From: - Divisional Forest Officer, Pangi Forest Division, Killar
To: - The Conservator of Forests (T) Chamba Circle Chamba (HP)

Subject: - Diversion of 211.8427 hectare of forest land for the construction of Dugar 500 MW Hydro Electric Project in favour of NHPC, within the jurisdiction of Pangi Forest Division, District Chamba (HP).

2. The point wise observations raised vide your office memo under reference is attended as under:-

Figure 10.10: Layout of Muck Disposal area

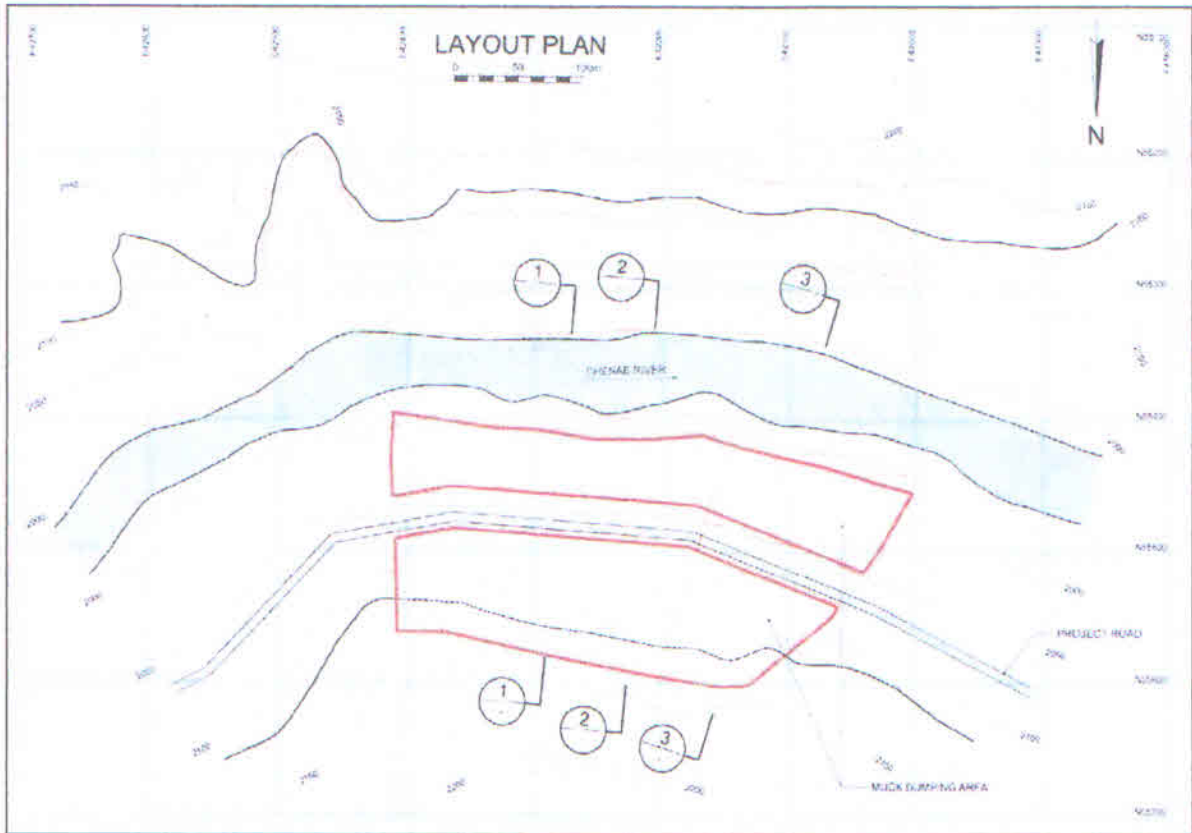
vii. The Muck dumping (8.5797 ha) and the job facility area (7 ha) can be taken on non-forest land. The justification for proposing the same on Forest land may be submitted.

Keeping the above requirement, one muck disposal site has been identified downstream of the proposed powerhouse with a total area of 8.58 ha and capacity has been worked as 8,75,000 cum which is much more than the total quantity of muck to be disposed of (refer to **Figure 10.10**).

For stacking of dumped material, concrete reinforced retaining walls are proposed to be built before dumping any material onto the sites (refer to **Figure 10.10**). In addition, leveling would
